Council Bill No. B 86-07

approving a revision to the M-R Development Plan for Missouri Book Services; and fixing the time when this ordinance shall become effective.

AGENDA REPORT
PLANNING AND ZONING COMMISSION MEETING
FEBRUARY 22, 2007

ITEM NO. 1-MR-07

1 MR SITE PLAN
SCALE 1" = 60'-0"

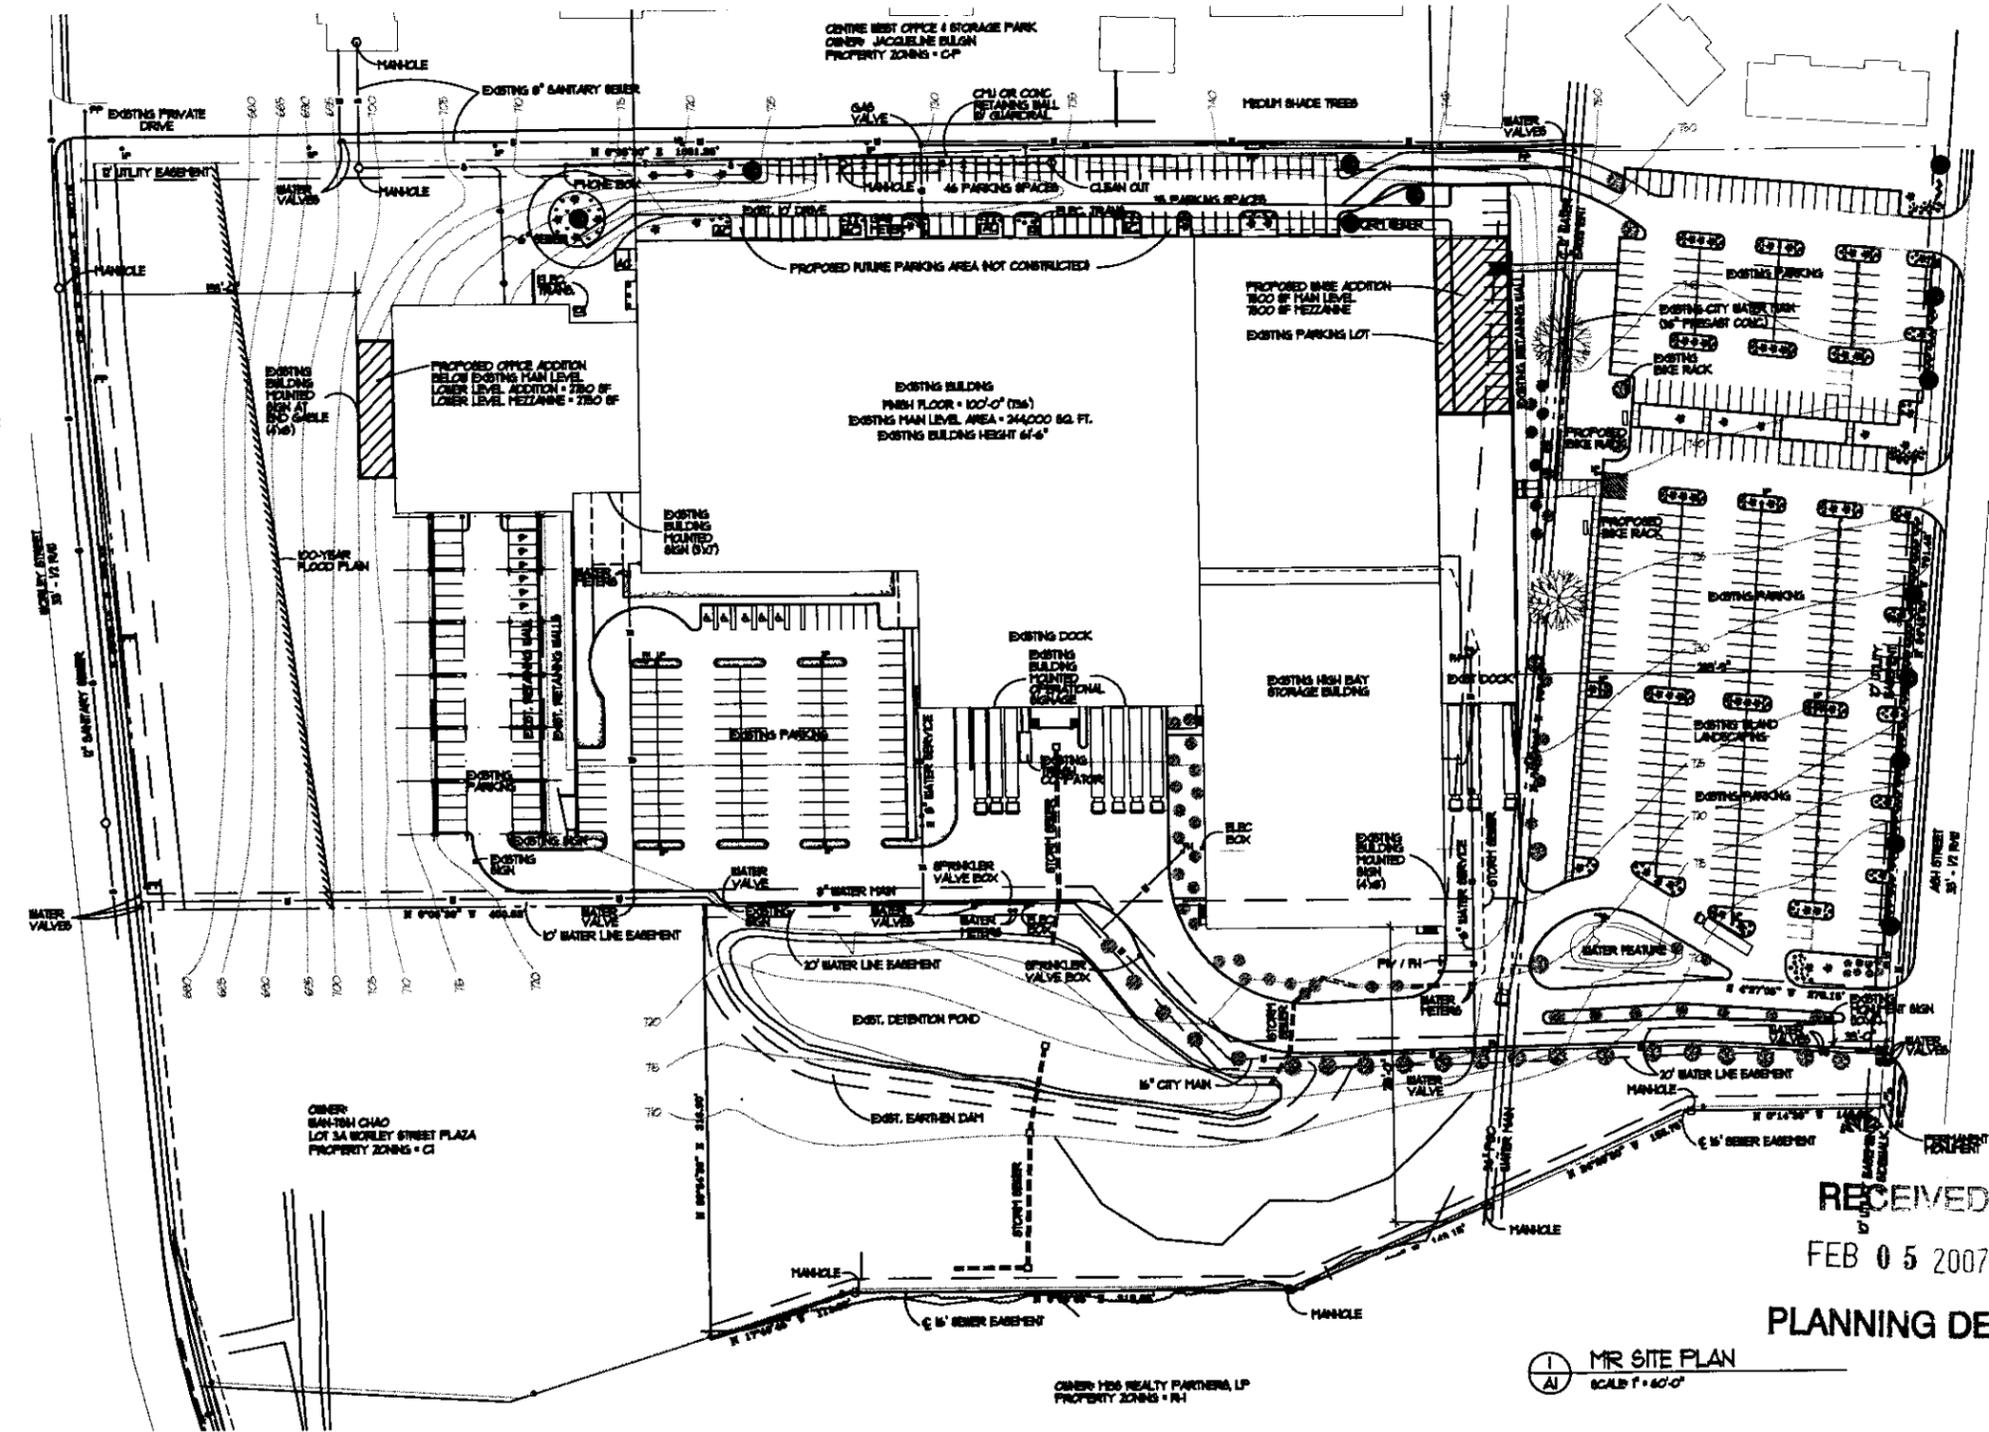
- A 5,500 square foot addition to the front of the office building that fronts on West Worley Street
- A 15,000 square foot addition to the southeast corner of the warehouse building
- A 16,650 square foot allocation for "future building expansion" (exact areas to be expanded are yet to be determined).
- A new parking lot along the east side of the site, which would contain 81 parking spaces. The parking area may eventually connect with the driveway to the east of the site, which serves the veterinarian office, the car wash and the self-storage facility.

In regard to the effect of these proposed changes to the site, the following should be noted:

1. Total open space will be 44%, which is far in excess of the 15% minimum

2. 30 bicycle parking spaces have been added to the site. Bicycle parking was not required when the building was first constructed in 1989 and when the building and parking additions were approved in 1999.
3. Total parking required is 612 spaces. Total parking provided (with credit given for the 30 bicycle spaces) is 628 spaces.
4. Existing signs and lighting are not proposed to be changed.

Approval of the proposed revised M-R development plan and the revised design parameters
